October 11, 2024

RE: Downtown Brampton Transit Hub (Bus Terminal) Preliminary Design, and Business Case Study – Comments on Transit Project Assessment Process (“TPAP”)

# TPAP, Preliminary Design, and Business Case Study

# SITE PLAN 3 TOWERS 0% LAND TAKING OPTION 1

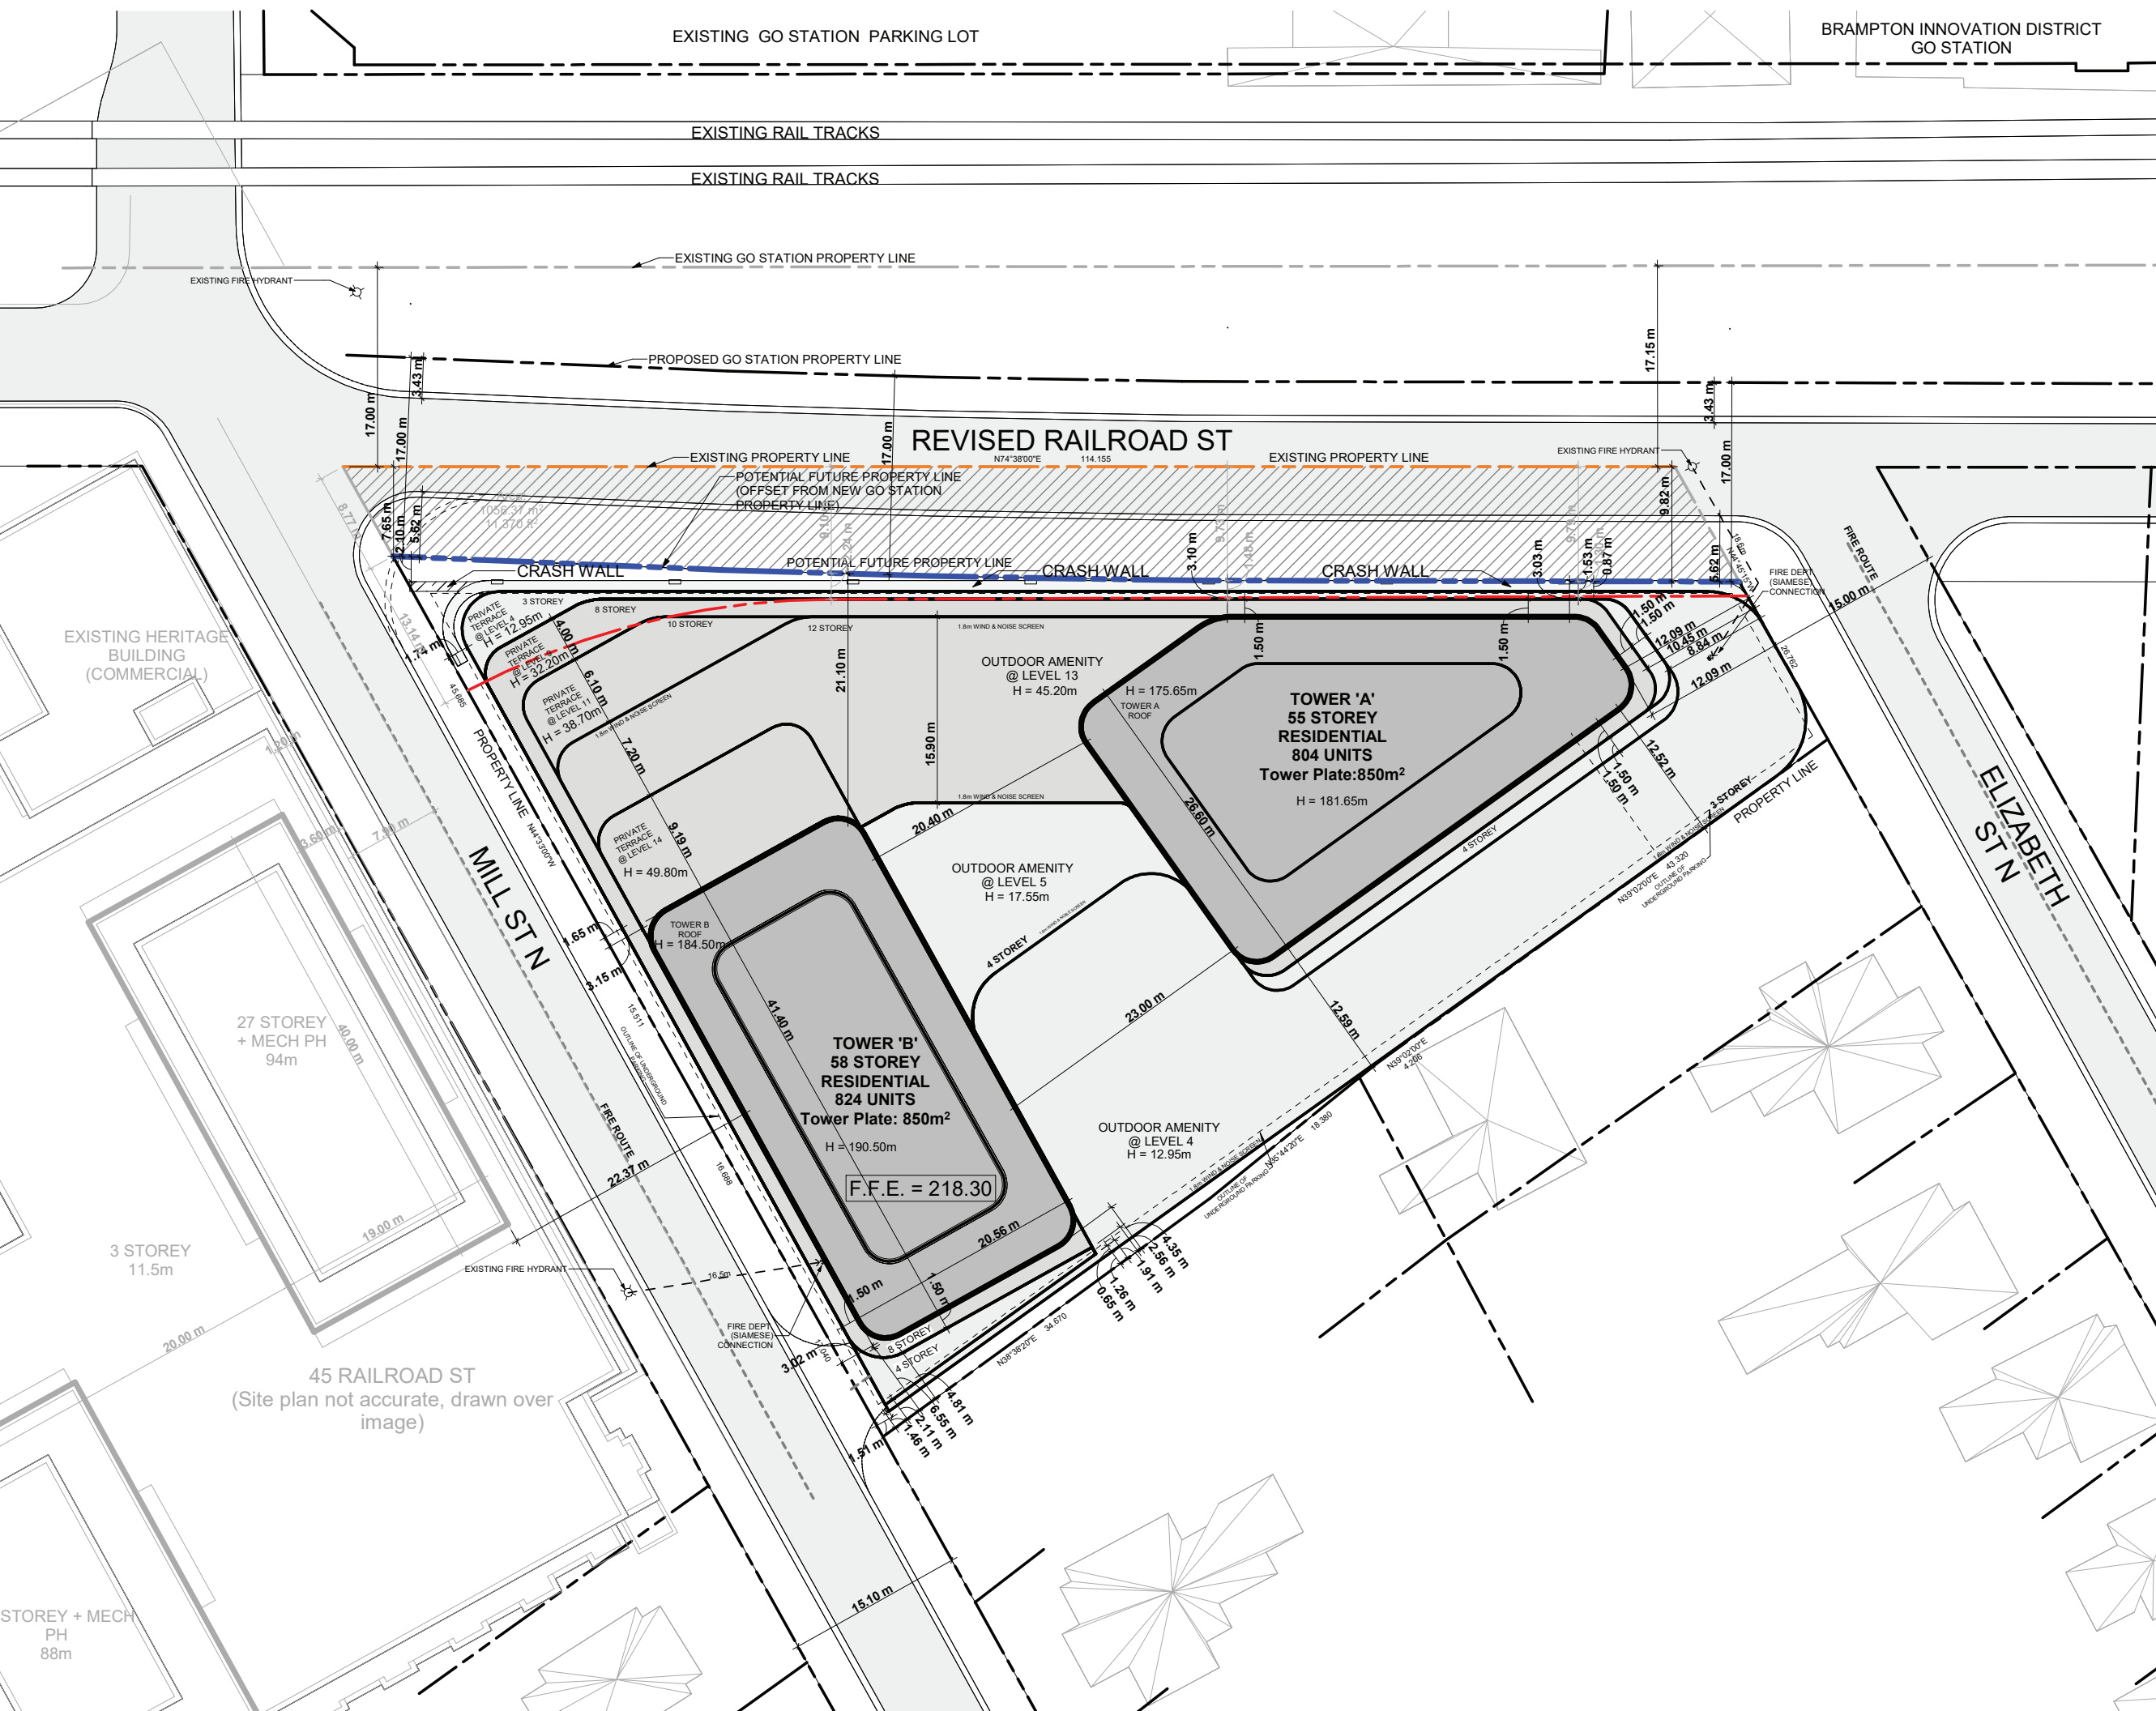
As shown in the development options enclosed with this letter, specifically Option 1, the Lands, with the closure of Railroad Street between Mill Street and Elizabeth Street, can accommodate three towers with standard 750m<sup>2</sup> floor plates and appropriate tower separation.

## SITE PLAN RAILROAD ST MAINTAINED 17.5% LAND TAKING OPTION 2

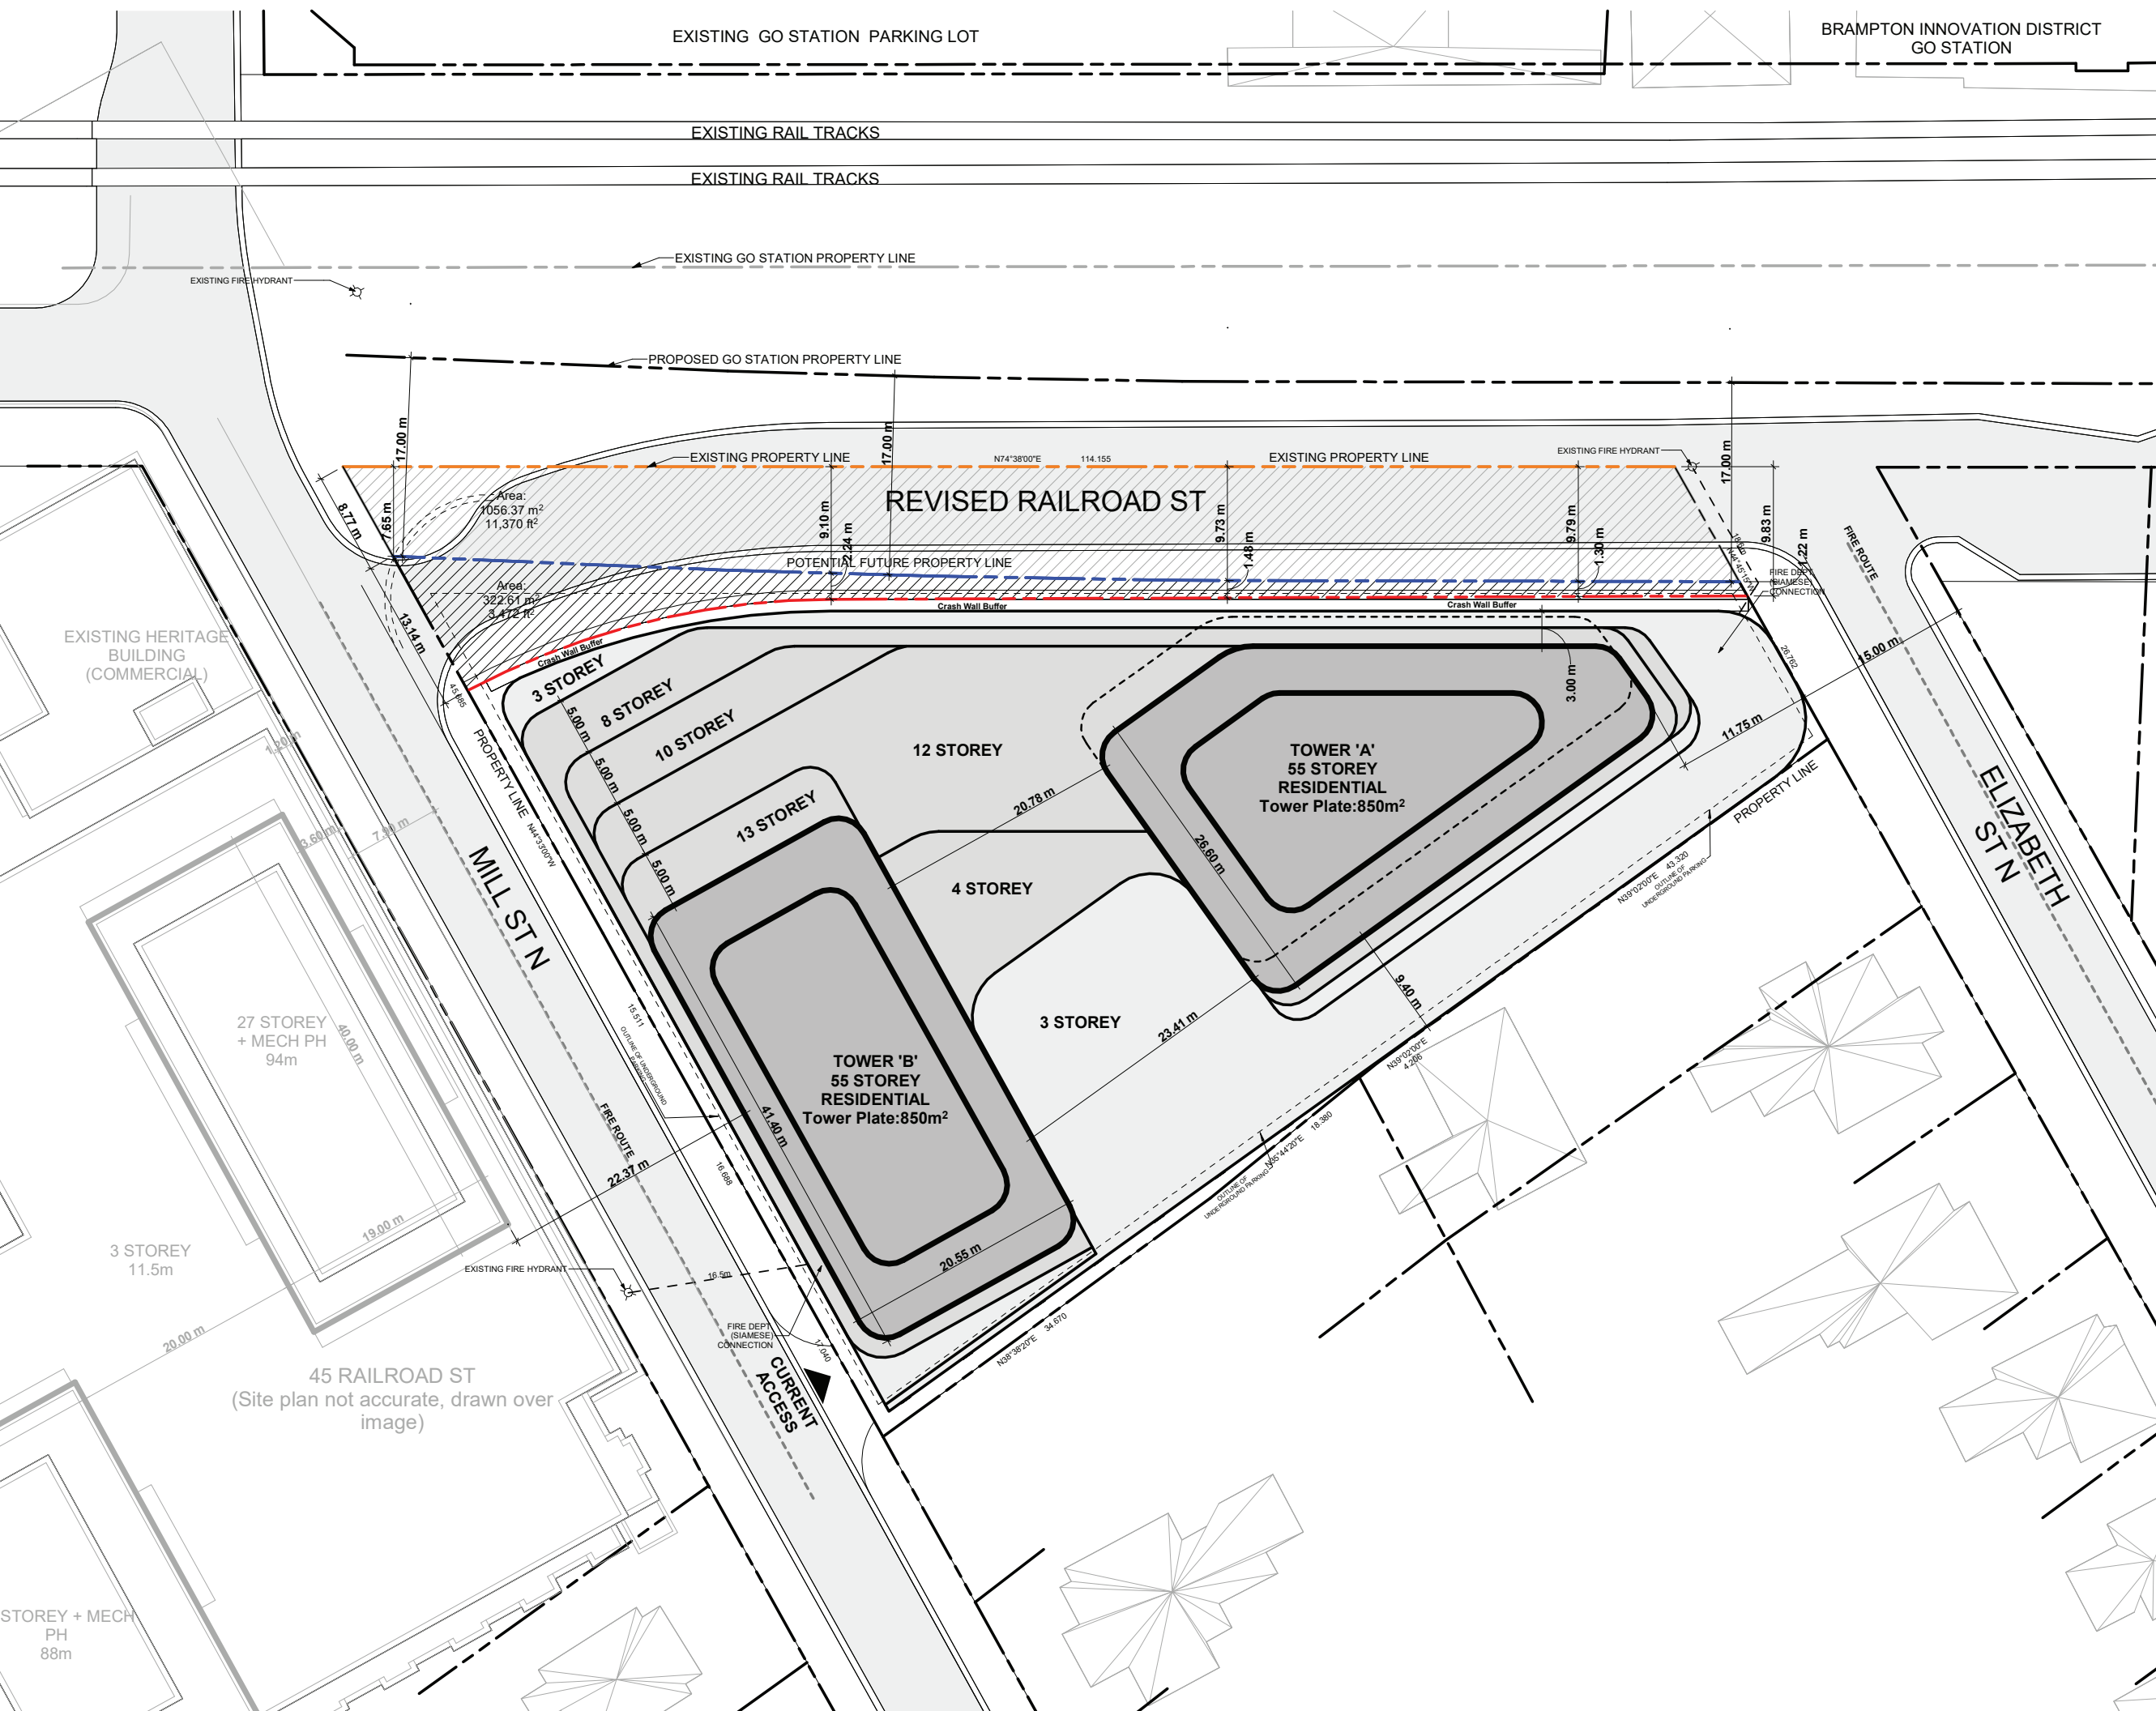
Maintaining Railroad Street as a through street, north of the Lands between Mill Street and Elizabeth Street, would require an acquisition of 17.5% of the Lands. Please see Option 2 enclosed with this letter. Option 2D – Alternative 1, with Railroad Street as a through street, north of the Lands between Mill Street and Elizabeth Street, including the bus stops, would require an acquisition of 22.8% of the Lands. Please see Option 3 enclosed with this letter.

The overlay of the proposed land takings due to maintaining Railroad Street as a through street, between Mill Street and Elizabeth Street, and Option 2D – Alternative 1 significantly constrains the Lands and results in the loss of development potential of a third tower, the reduction of approximately 28,500m<sup>2</sup> (307,200ft<sup>2</sup>) of Gross Floor Area (GFA) and the loss of 361 units. Please note that Option 2 and 3 include tower floor plates that are approximately 850m<sup>2</sup>. The towers were expanded from 750m<sup>2</sup> in Option 1 to approximately 850m<sup>2</sup> in Option 2 and 3 to try and recoup the significant loss the proposed land taking would have on the Lands. If Option 2 and 3 were designed with two 750m<sup>2</sup> towers, the loss in GFA would be approximately 36,700m<sup>2</sup> (395,000ft<sup>2</sup>), and the unit loss would be 489.
